IEC/IEEE 60802 Traffic Class mapping and Stream Admission

Hirschmann Automation and Control GmbH

May 2024

Figure 6 – Traffic type translation example

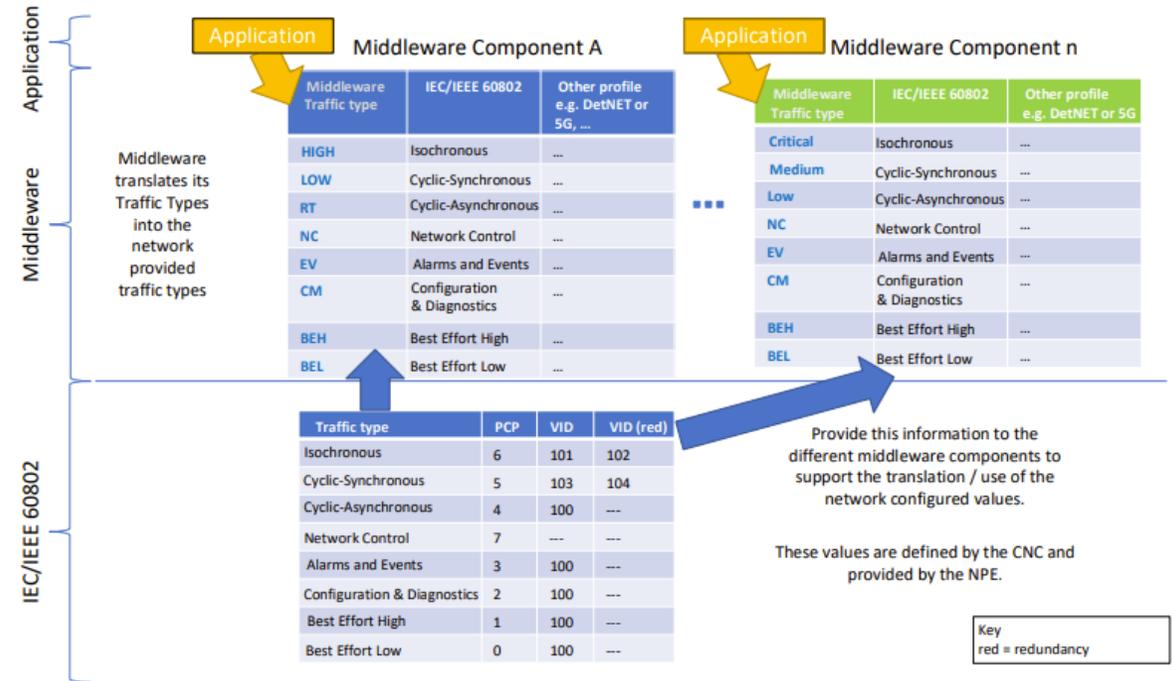
- This gives the impression that IEC/IEEE 60802 provides two ways to get the information required for this mapping:
 - a YANG module
 - a I2vlan interface naming scheme
- However, while a naming scheme is described, no such YANG module is present in the document.

- Issue with this: the letters encode traffic types that are not normative!
- This leads to the problem that currently there is no standardized or specified way that allows the application or middleware to get the traffic type names and characteristics that are associated with the traffic type codes!

→ How are the traffic types that are used specified in a binding way in a final deployment?

Figure 7 – IETF Interfaces used for Traffic Type Translation

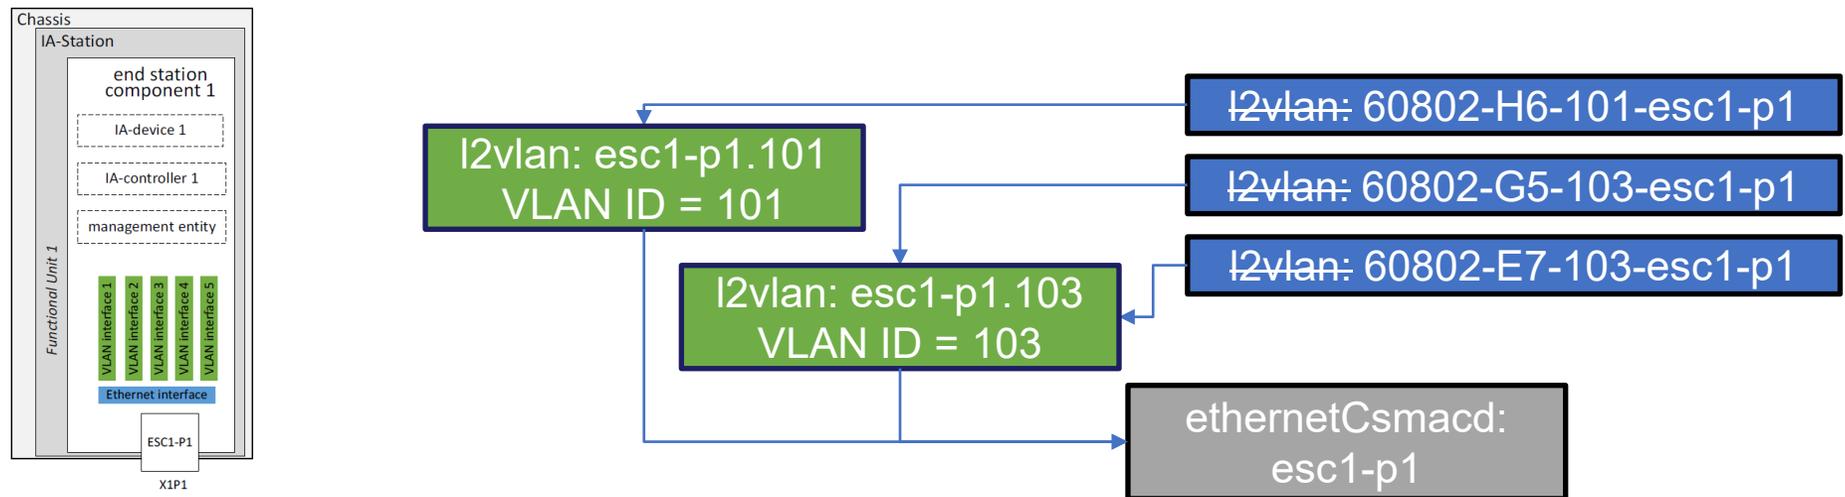
- There are 2 issues with this:
 - Information relevant for selecting the forwarding path (VID) is tied to information only relevant for prioritization and application configuration
 - (Some) Unix like systems only allow I2vlan interfaces with unique VLANs per physical interface
- The second point causes problems of how to proceed with mapping interfaces, if the VLAN already exists on the given interface, e.g., `esc1-p1.101`.

- Proposal: use intermediate VLAN interfaces **without** encoding priorities:
 - Use I2vlan interface with the VID only
 - Use generic interfaces tied to the I2vlan interfaces encoding additional information like traffic type encoding and priority and providing it to the application /middleware
